**MERCERSBURG ACADEMY**  
**HEALTH CENTER PRE-BID CLARIFICATIONS**

**August 22, 2017**

**RESPONSE ISSUED 8/28/17**

L032

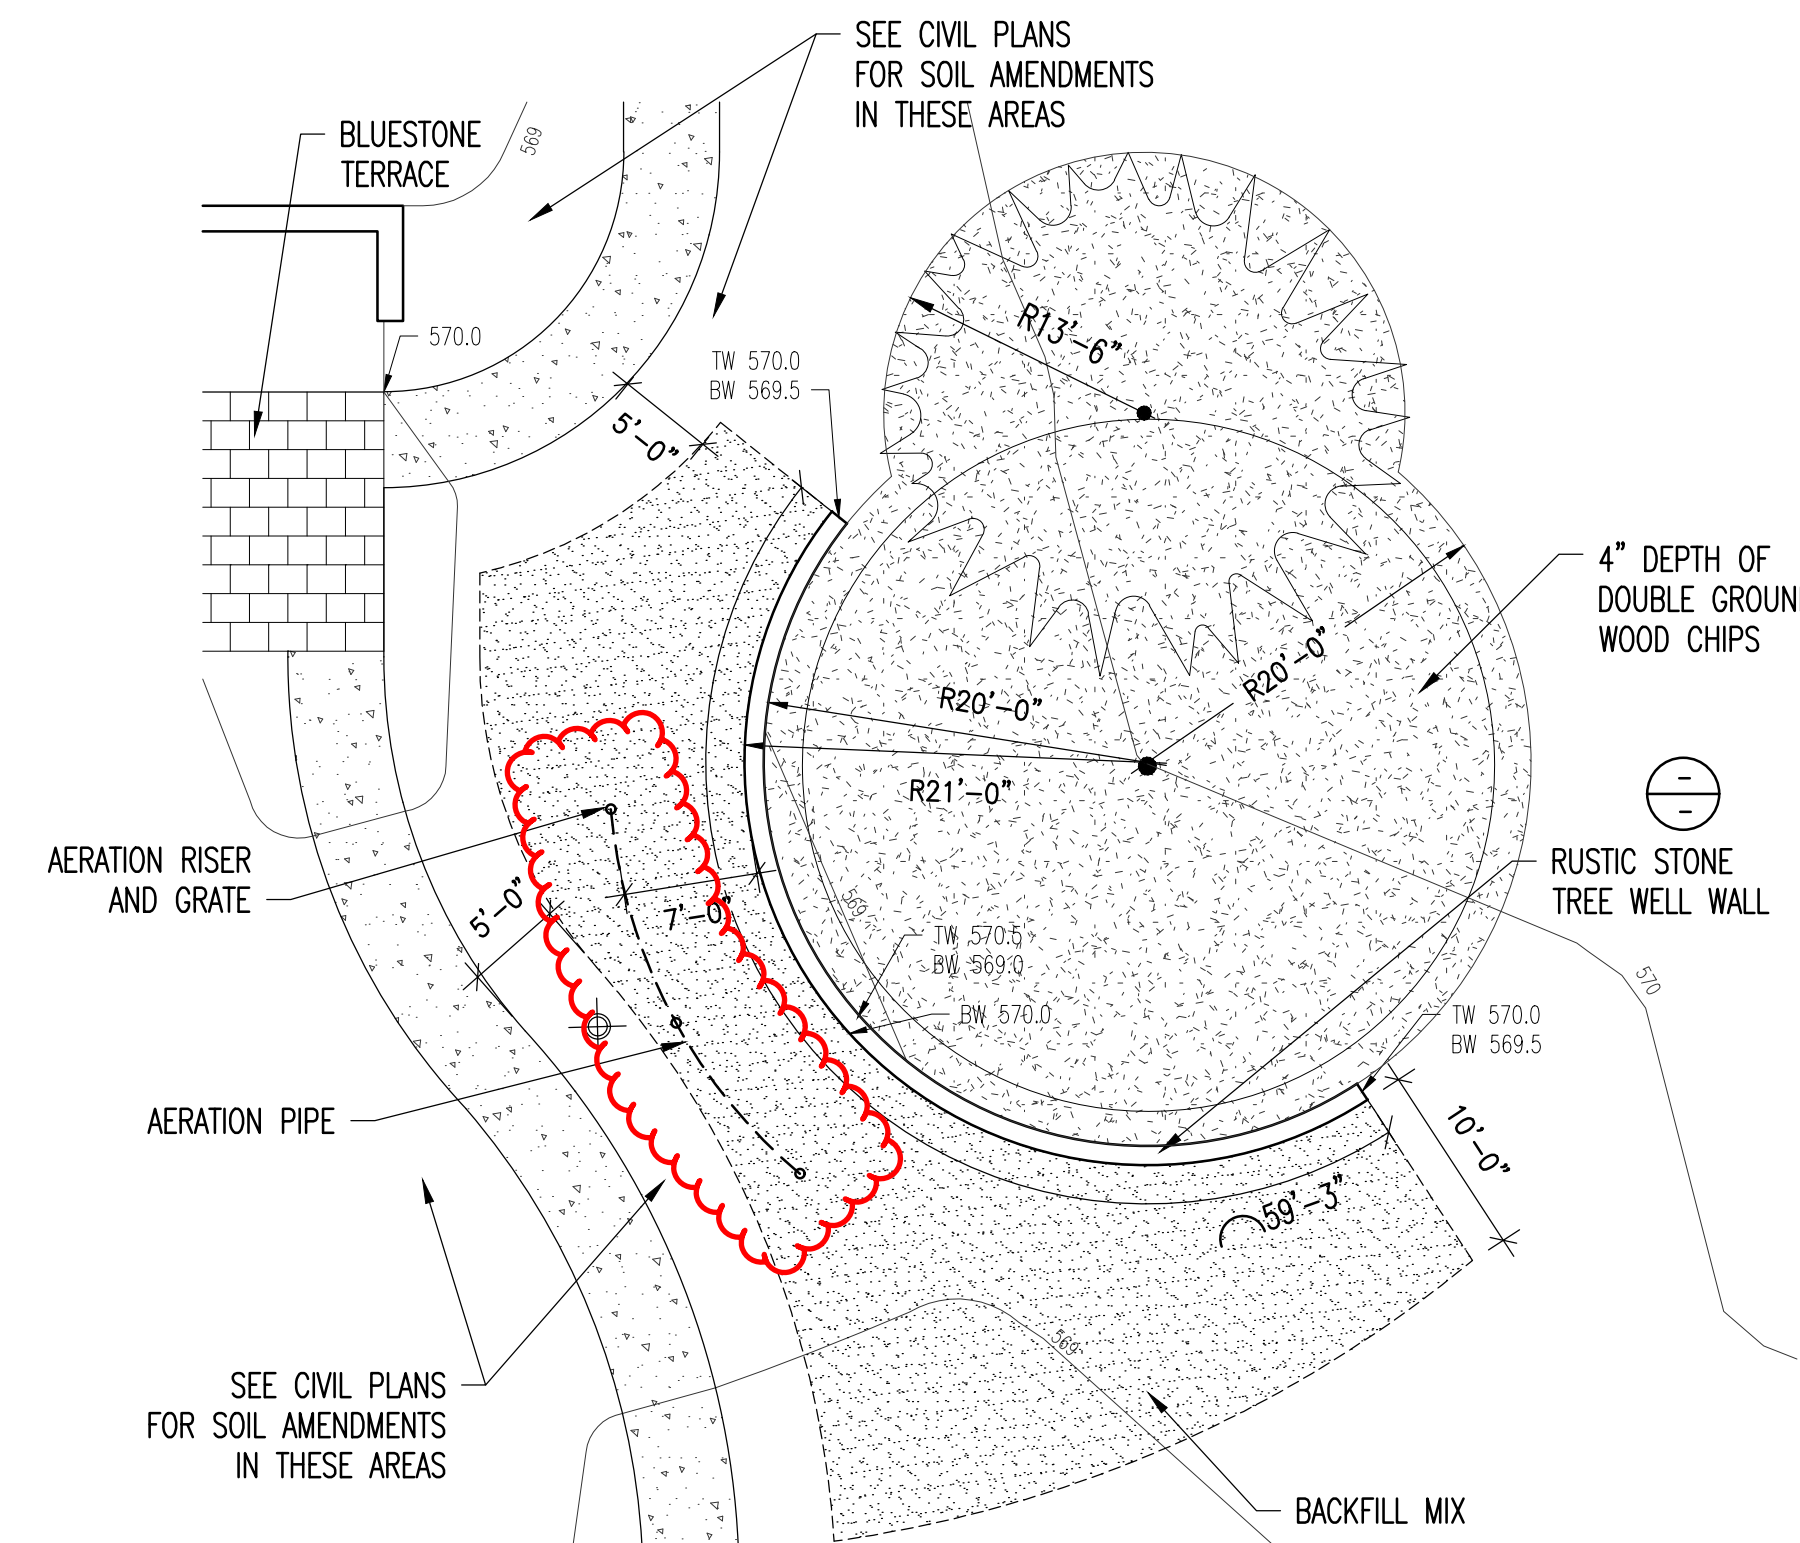
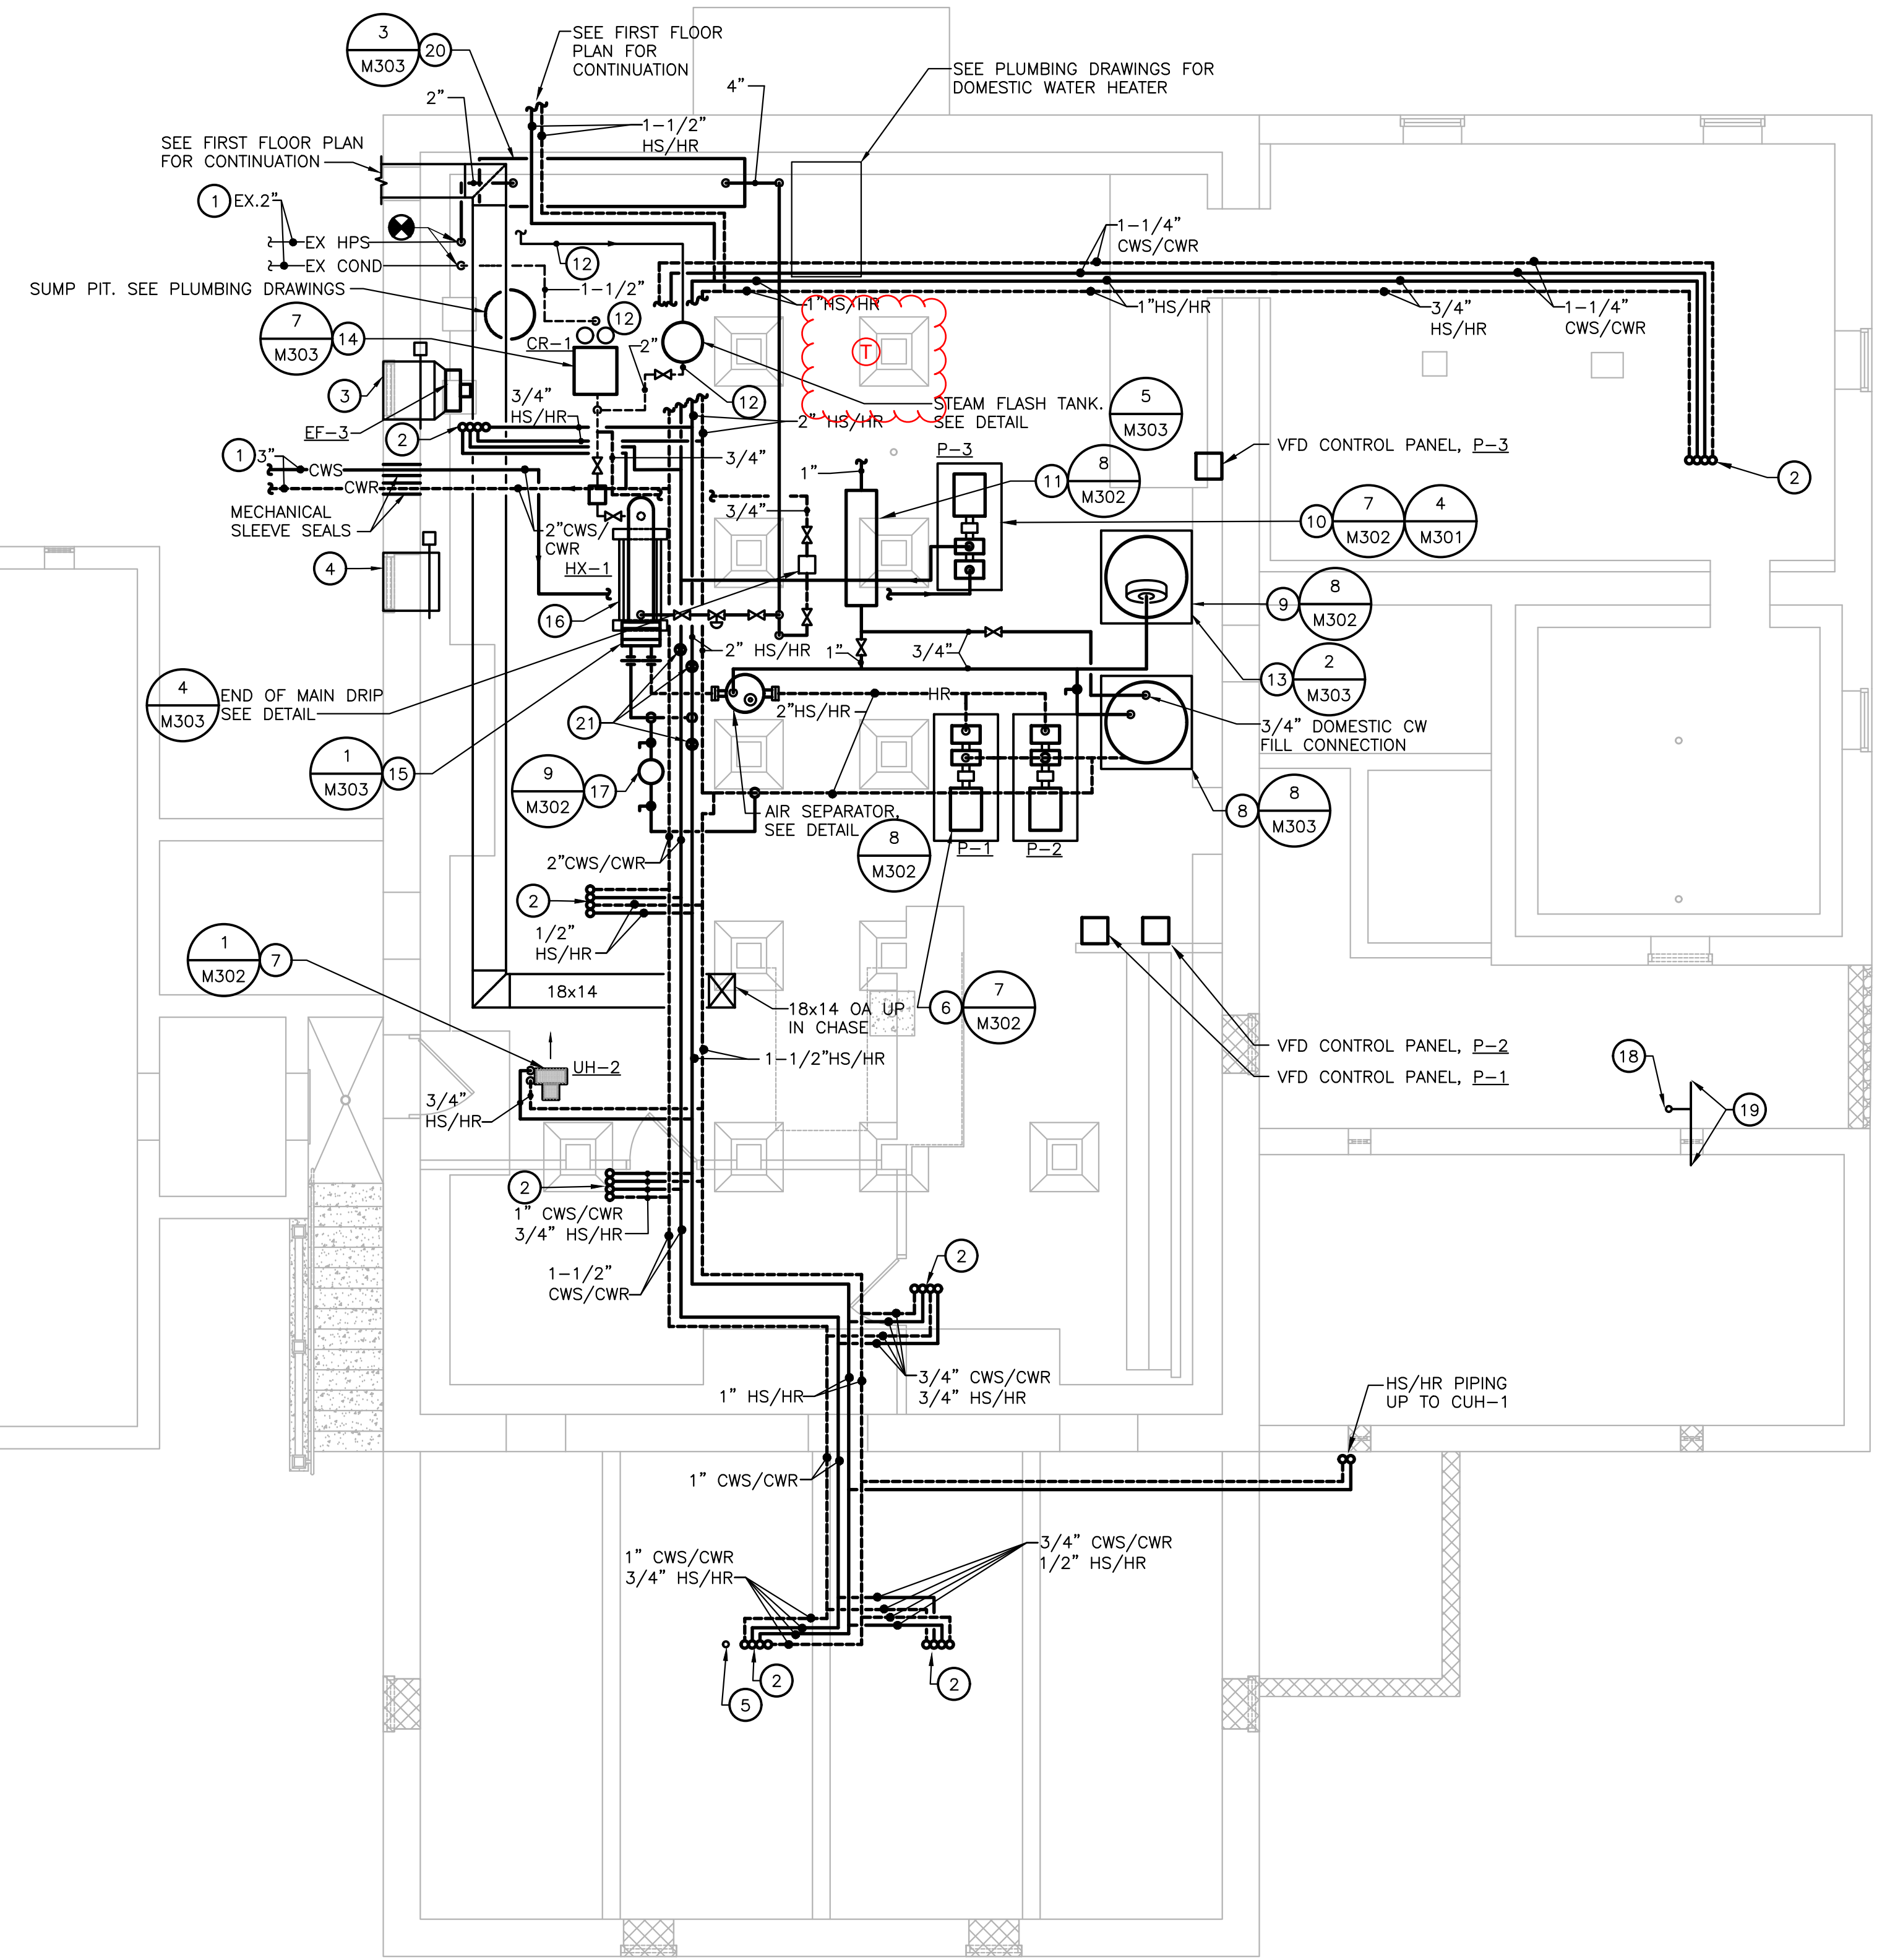
8. Looking for more detail for the fill between the tree protection wall and the sidewalk (Sheet L032), I don't have enough depth to put the soil mix in. They call by the detail for the stone base to start at the bottom of the wall which on the sidewalk side is 570.0, and the sidewalk is at 570.0. So I have no depth to put in the piping or the mix.

**Fill amount varies from 1' depth at the center of the wall, to meeting grade at the ends of the wall. Fill is also about 2' against the south face of the building. See attached sheet to revise the extent of piping and risers from about 63 LF to about 22 LF, to allow soil coverage. Thanks to the contractor for picking this up.**

**BASEMENT FLOOR PLAN - MECHANICAL**

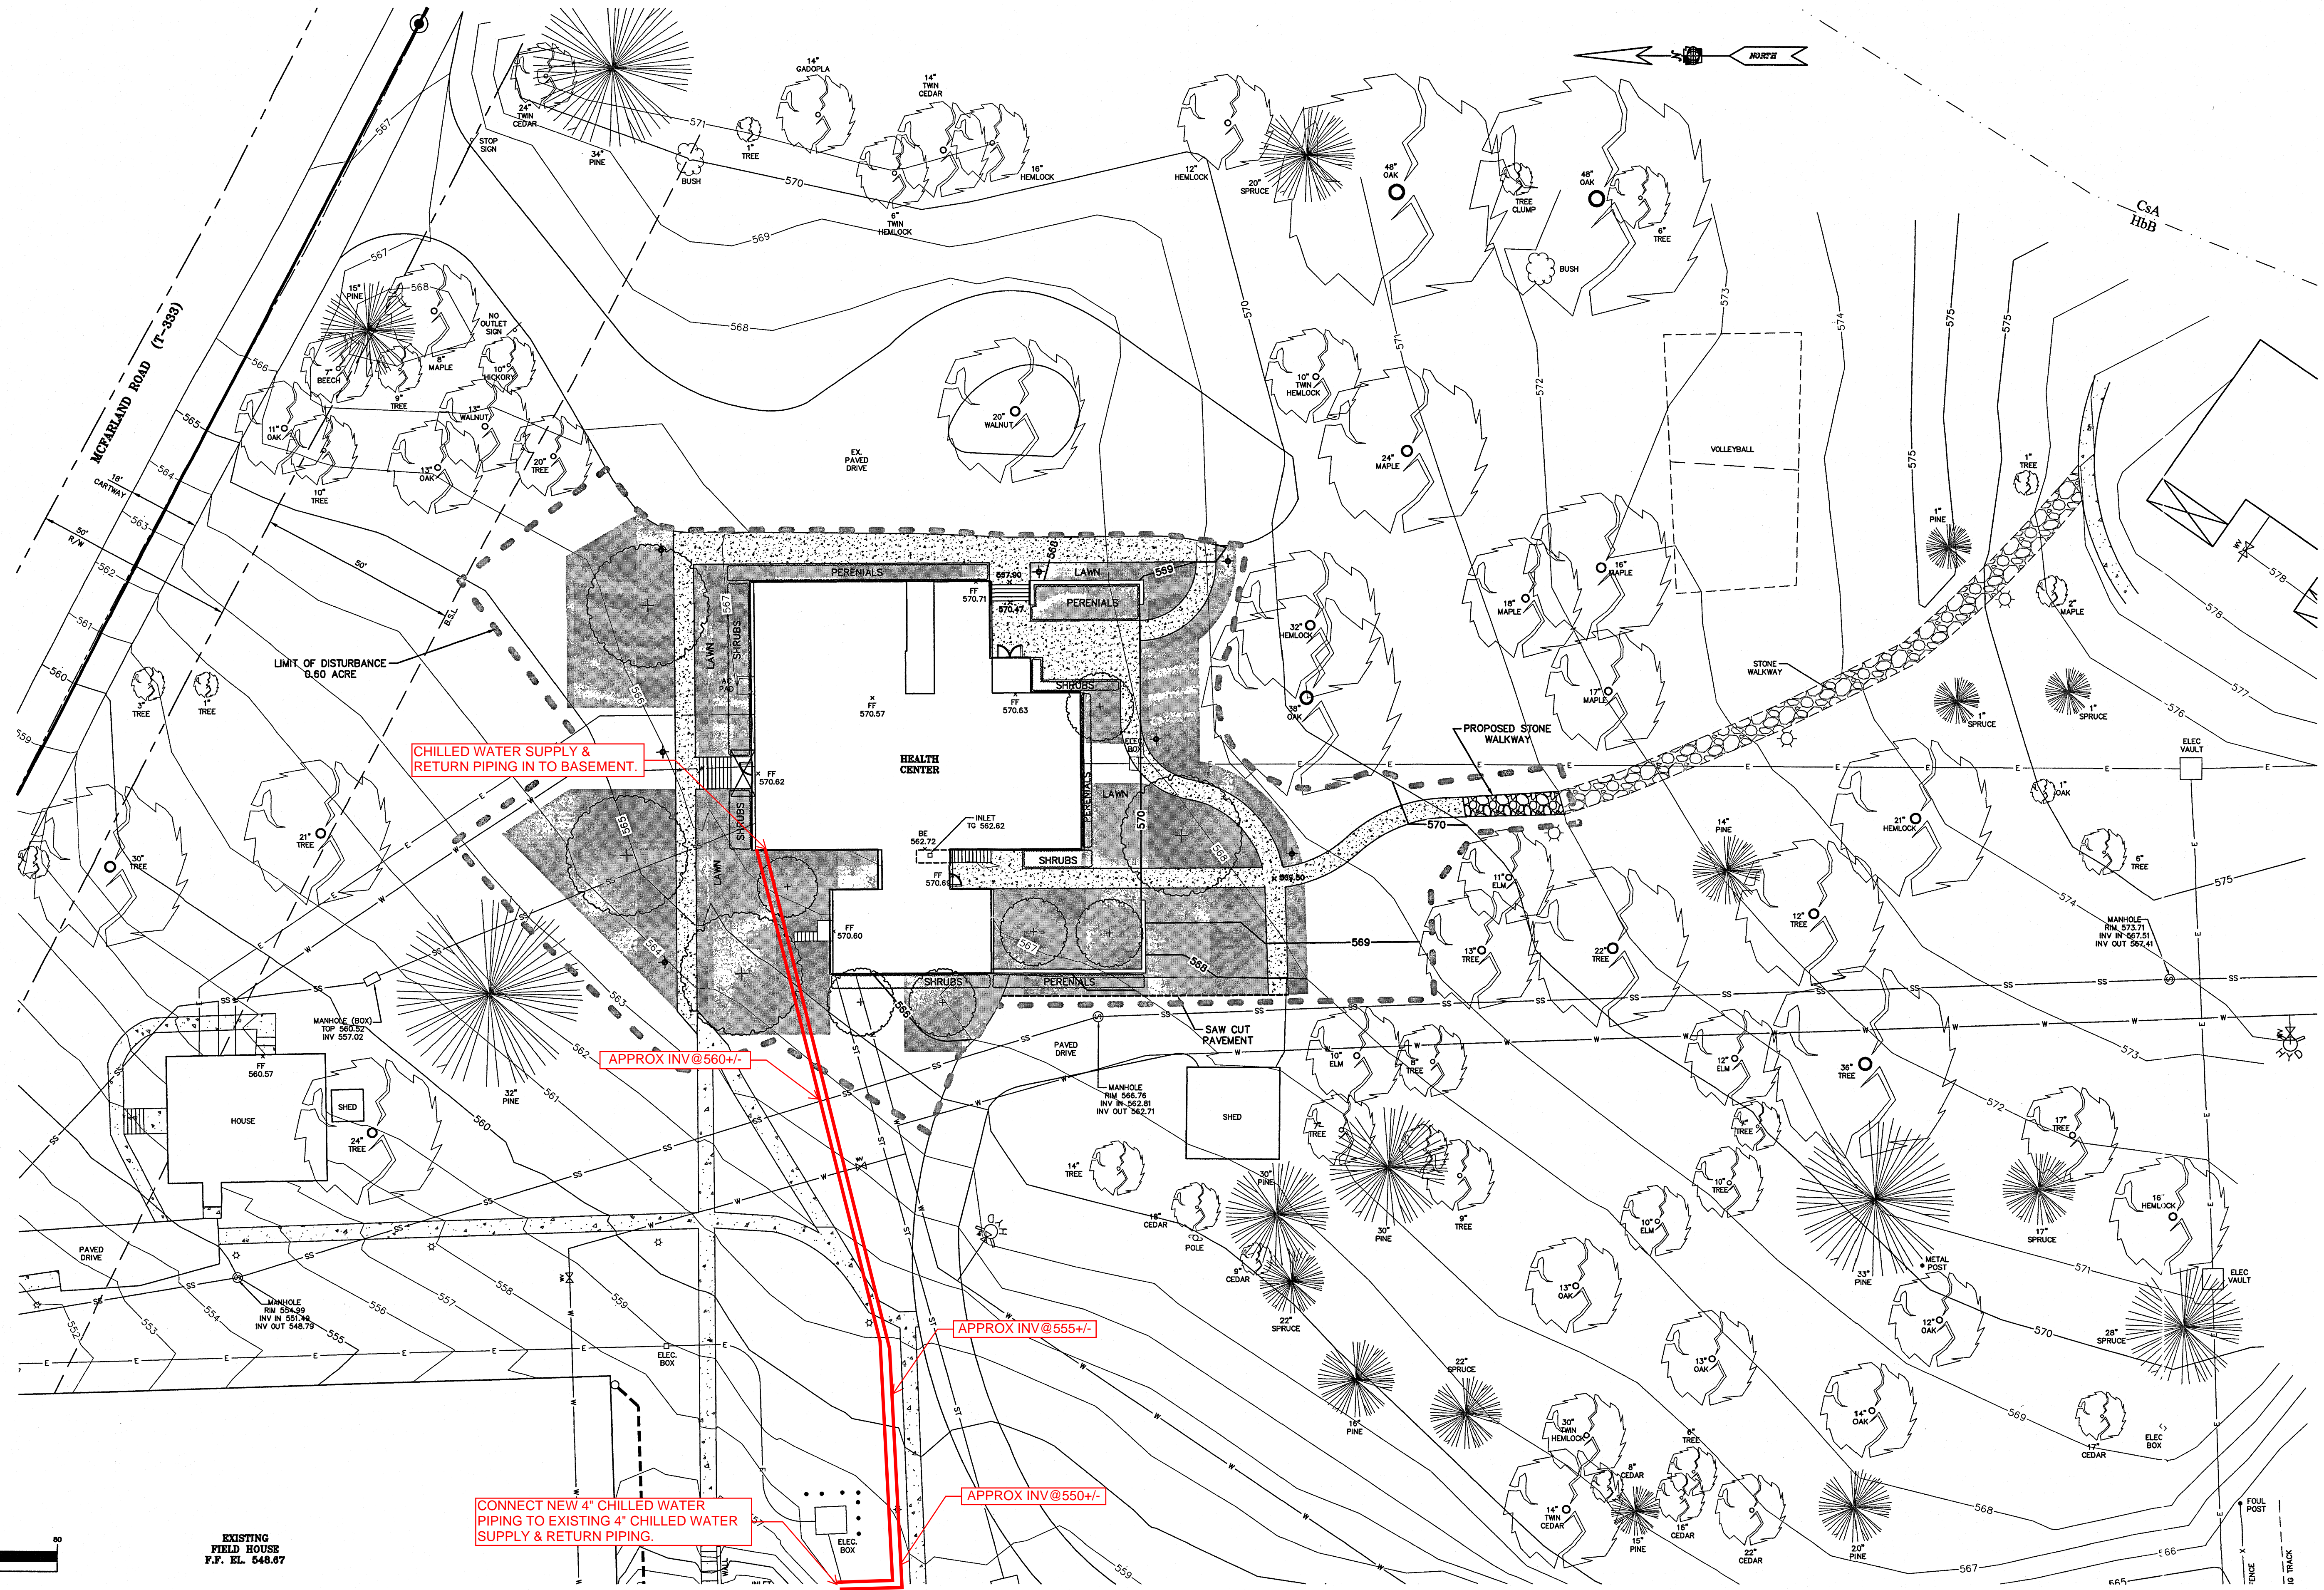
3) The Chilled Water line noted on M100 is shown to extend 5' outside of building with a note to see Civil drawings for continuation. Civil plans don't show CW line. Please clarify?

7. Please see the two attached drawings which request for direction in regards to a plan to access to these two locations, we reviewed the existing conditions in the field and it has been deemed that these areas are inaccessible due to obstructions or limited space to fit an actual person.

**Still being coordinated between Civil and Mechanical Engineers. Will send out reply when finalized.**

**Ref RFI drawing M100 (Basement Floor Plan): Each contractor is to determine the application based on their field visit and make adjustments to their price accordingly.**
